Norfolk Vanguard Offshore Wind Farm Development Consent Order (the Project)
Case reference no: EN010079
The Applicant: Norfolk Vanguard Limited

Request to submit information into the Examination: Application Documents Errata, and Change Report.

Norfolk Vanguard Offshore Wind Farm Change Report

Applicant: Norfolk Vanguard Limited
Document Reference: Pre-ExA; Change Report; 9.3

Figure:	7	Drawing No:	PB4476-008-002-007			
Revision:	Date:	Drawn:	Checked:	Size:	Scale:	
04	12/12/2018	LB	JA	A3	1:5,000	
03	28/11/2018	LB	JA	A3	1:5,000

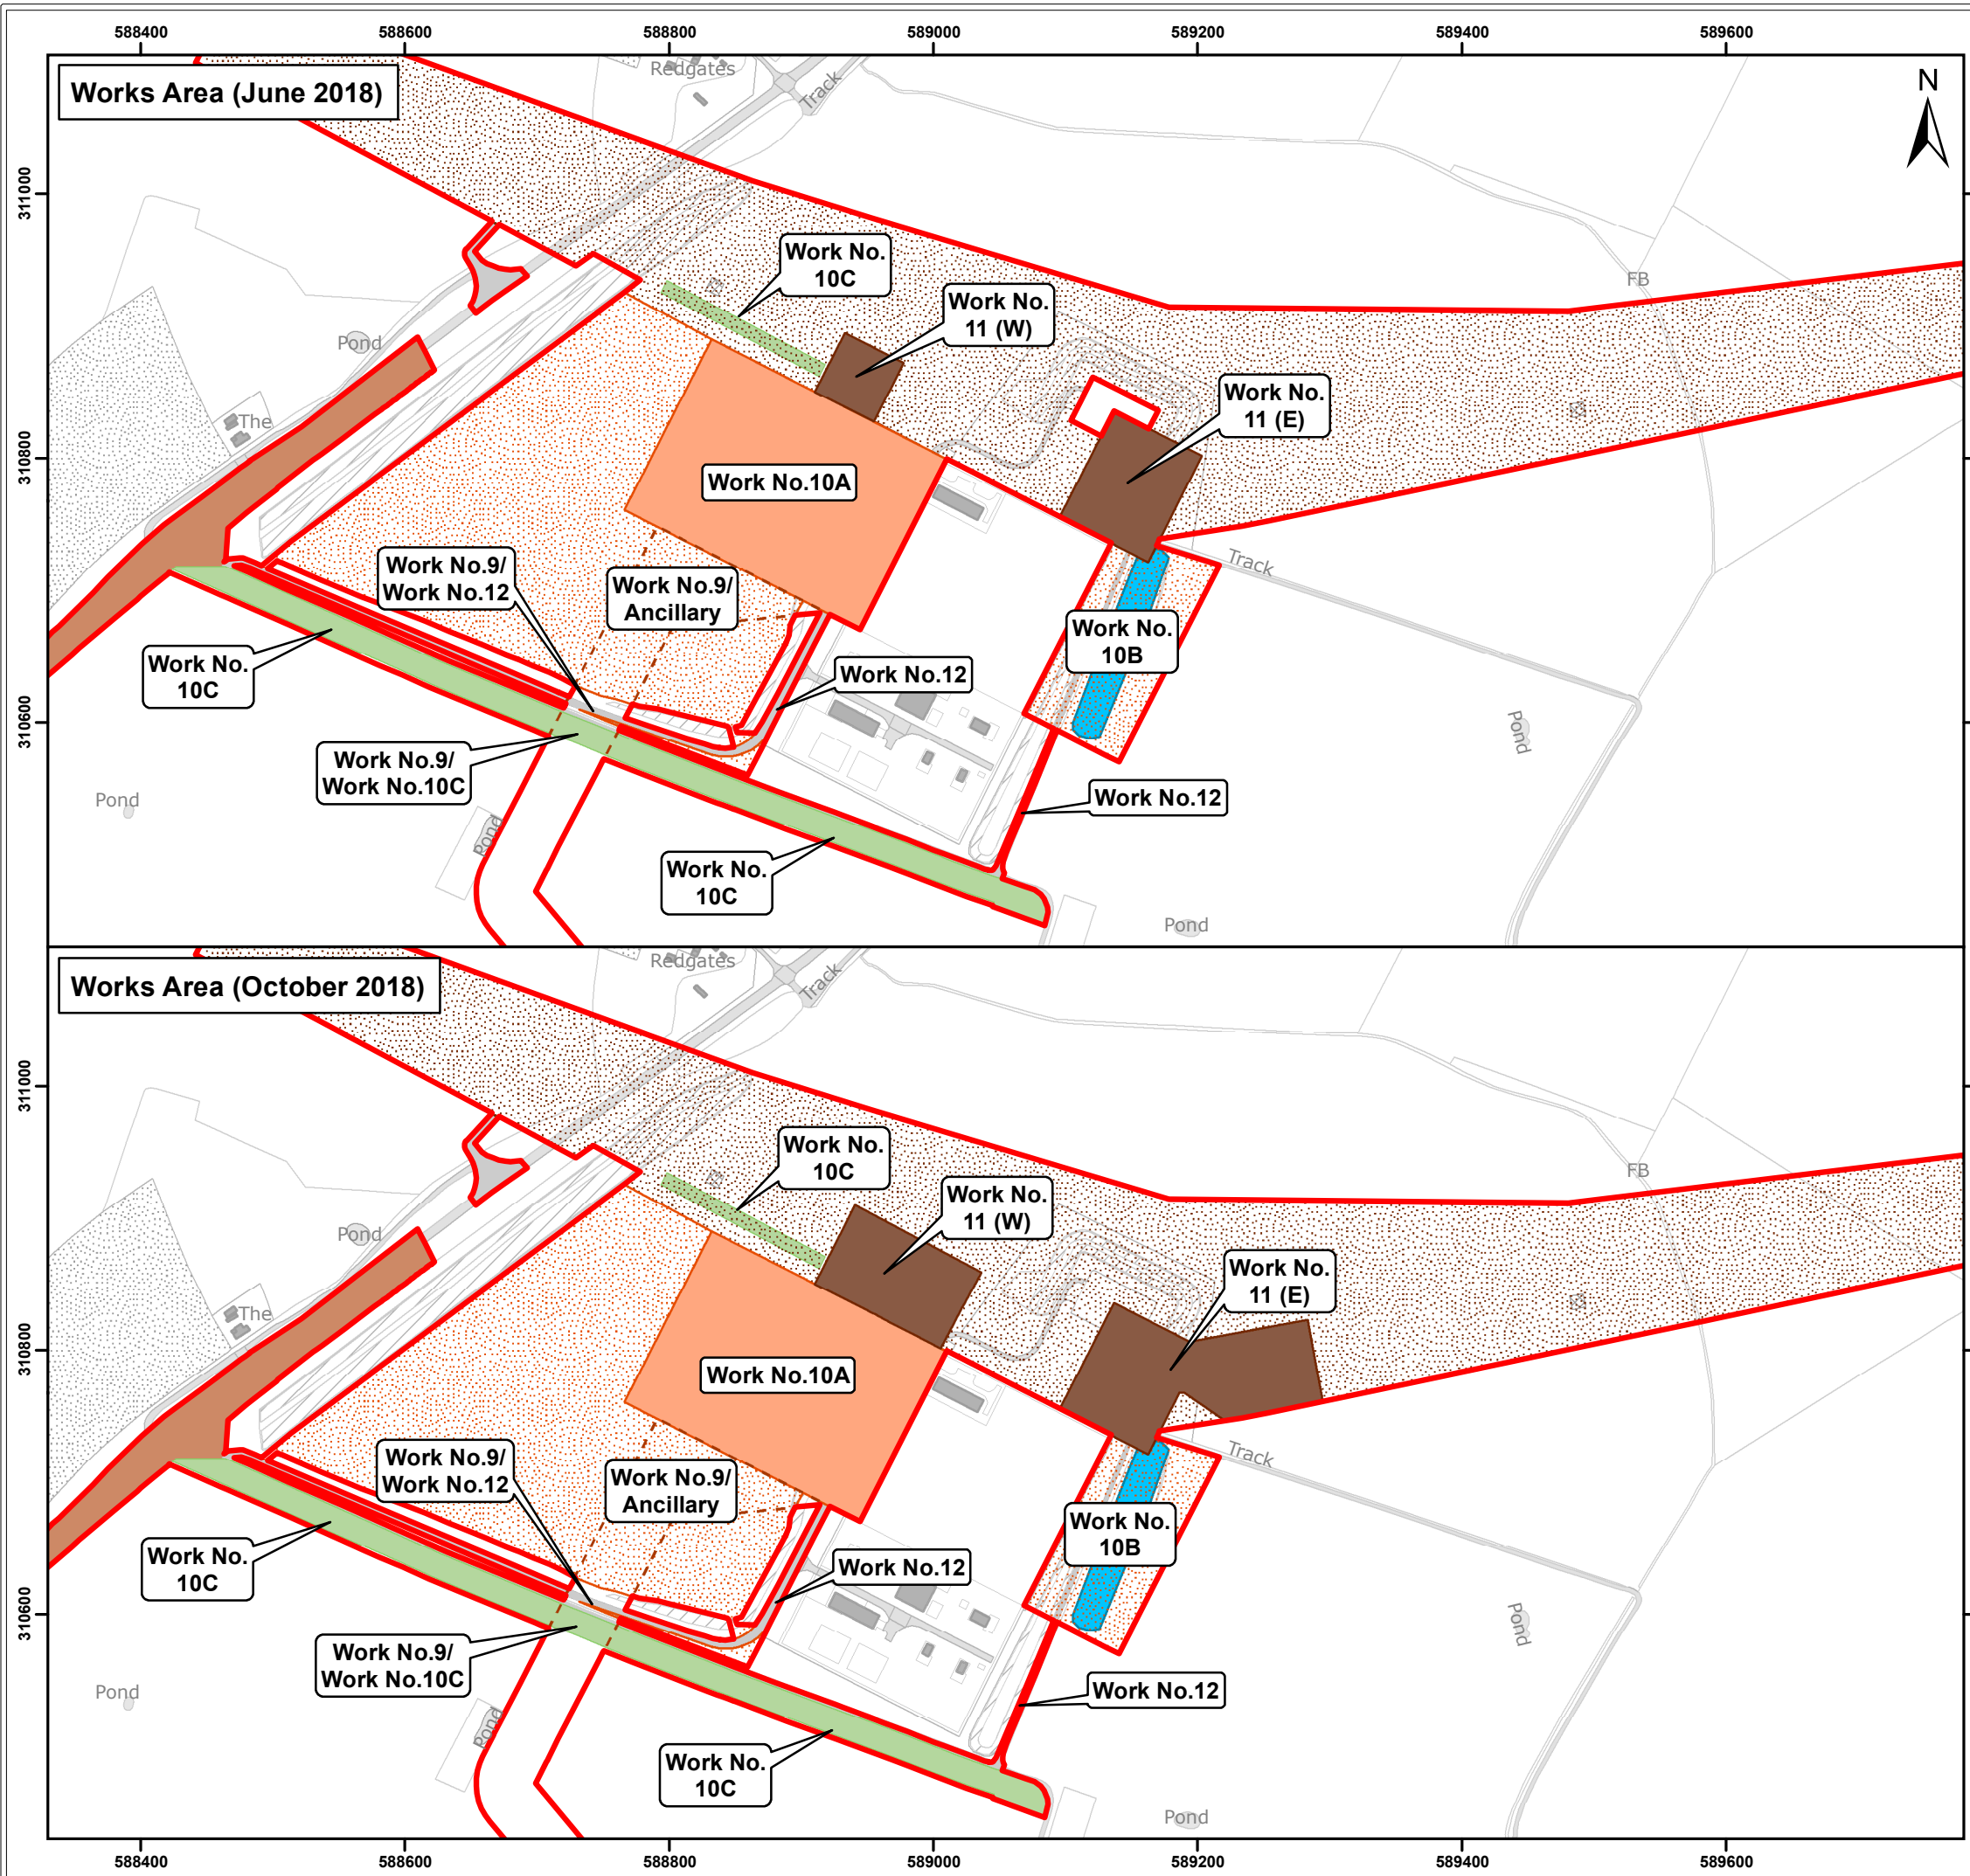
89. Two amendments have been identified and requested by National Grid to the dimensions of the tower search area footprints - Work No. 11 (E) and Work No. 11 (W) – as defined on the submitted Works Plan (DCO ref: 2.4). In addition, National Grid has requested that the Order is amended to permit a permanent right to be acquired for two sections of the overhead line which will be repositioned as a result of the new tower locations (Figure 8). Discussions with National Grid's advisors have also suggested that the area scheduled for permanent new rights within National Grid's sealing end compound (at plot 41/33) should be enlarged to permit the acquisition of rights over the whole compound area. It is therefore proposed to extend this plot accordingly (Figures 7 and 8). It should be noted that National Grid's final approval of the changes proposed to the overhead line and related infrastructure is awaited. The two tower amendments represent a widening of the available search areas within which the two overhead line towers will be located. The permanent footprint and heights of the two new towers will be unchanged from that previously assessed. The increased size of the search areas is required to provide flexibility to National Grid when micrositing the position of towers at the detailed design stage. Although these changes fall within the existing Order limits, the nature of the compulsory acquisition powers being sought (freehold acquisition/permanent new rights/ temporary possession) in the affected land parcels will change, with a net increase in the land subject to permanent compulsory acquisition.

90. The proposed increased dimensions of the two tower search areas avoid any interaction with a block of proposed tree planting to be undertaken as part of the embedded mitigation for Norfolk Vanguard (Work No. 10C) and avoids any interaction with previously approved landscape mitigation associated with the operational Dudgeon substation.

91. The location of these amendments is centred on National Grid Reference TF 890 108. The proposed changes are shown on Figure 7, which also indicates the originally submitted extent of the tower search areas and overhead line temporary works.
92. The amendments are located wholly within the EIA study areas identified within the submitted Environmental Statement. Table 2.15 provides a consideration of this proposed amendment in relation to each of the previously assessed onshore EIA topics.

Figure: 9	Drawing No: PB4476-008-002-009				
Revision:	Date:	Drawn:	Checked:	Size:	Scale:
02	12/12/2018	GC	JA	A3	1:2,500
01	28/11/2018	LB	JA	A3	1:2,500

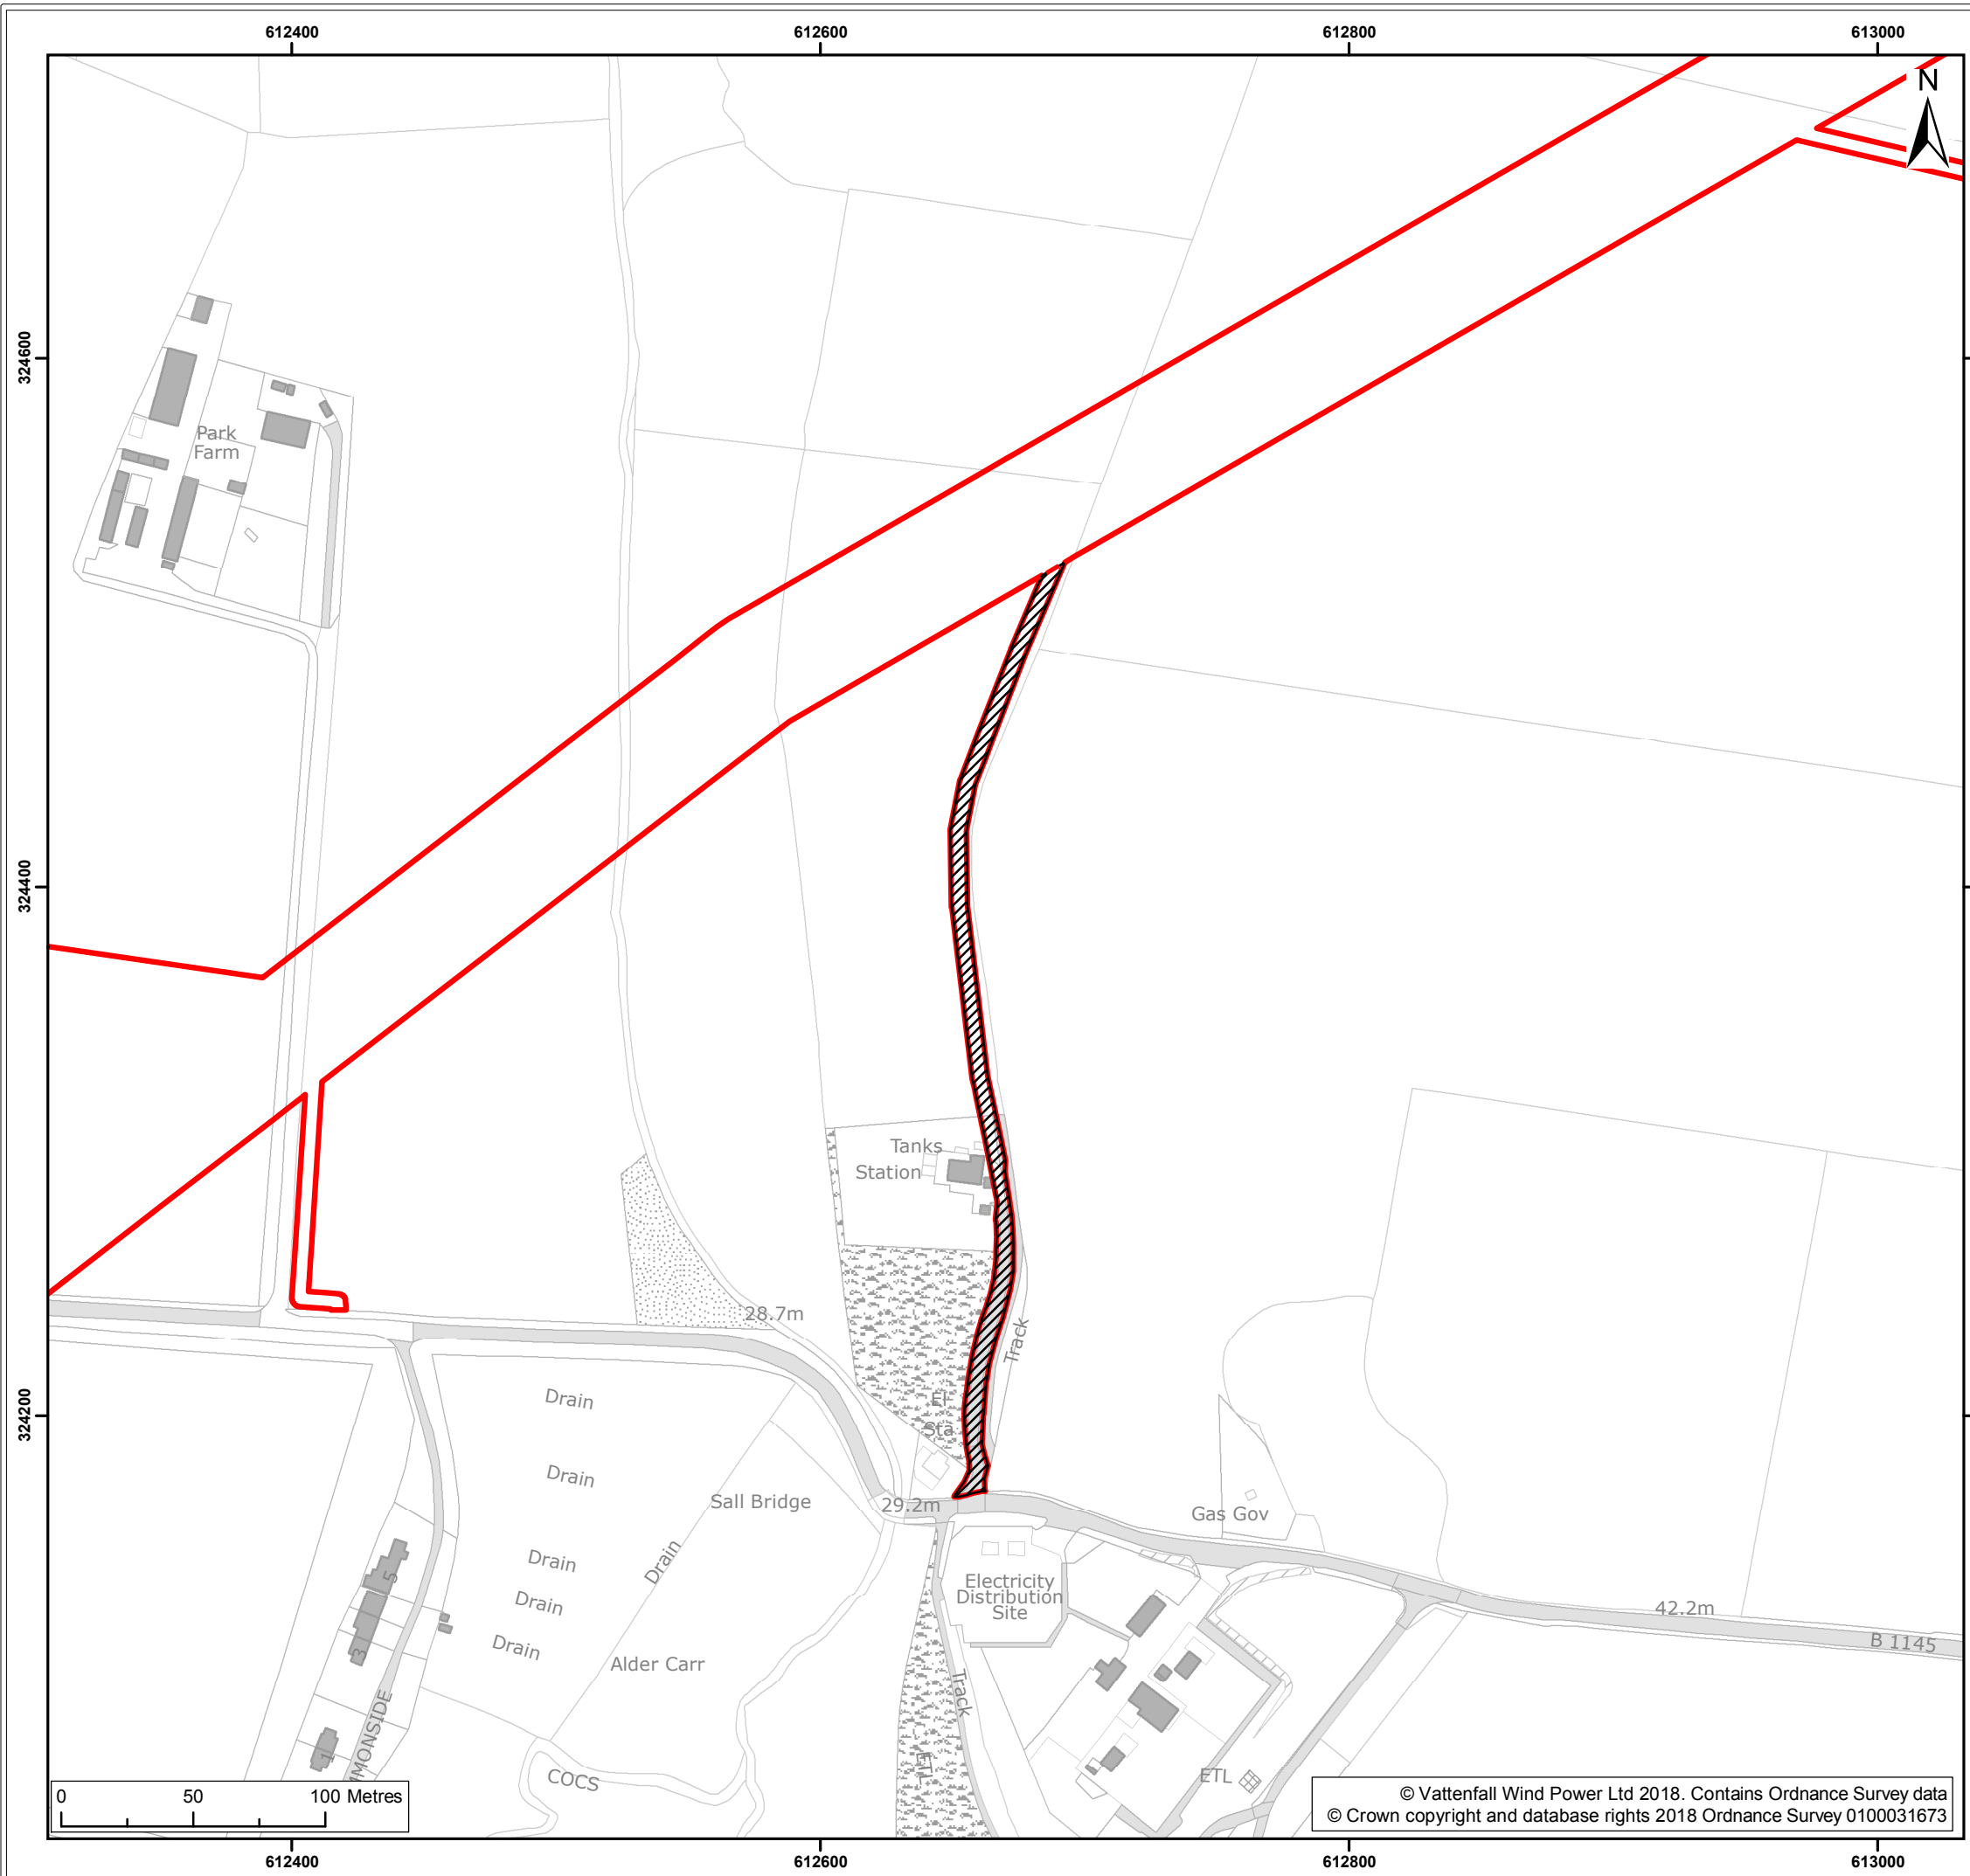
2.2.8 Onshore cable route operational access amendment – Plot No. 20/12, 20/13, 20/14, 20/15, 20/16 (Land Plans Sheet 20)

following a recent detailed site walkover and further on-site investigations, it has become apparent that the proposed side access as shown on sheet 20 of the Land Plans (parcels 20/12, 20/13, 20/14, 20/15, 20/16) is not tenable and this operational access has therefore been removed from the Order limits.

95. The location of the amendment is centred on National Grid Reference TG 126 243. The proposed access amendment is shown on Figure 9, which indicates the extent of the Order limits within the original application that are no longer required.
96. No alternative access is proposed and its removal will result in **no changes to the impacts previously identified**. The findings of the submitted Environmental Statement remain valid.

Removal of proposed operational access to onshore cable route at National Grid Reference TG 126 243. Figure 9	Following a detailed site walkover and further on-site investigations the proposed side access as shown on sheet 20 of the Land Plans (parcels 20/12, 20/13, 20/14, 20/15, 20/16) is not tenable. No alternative is required.	No change	Land Plans, Works Plans and Book of Reference to be updated. No other documents affected.
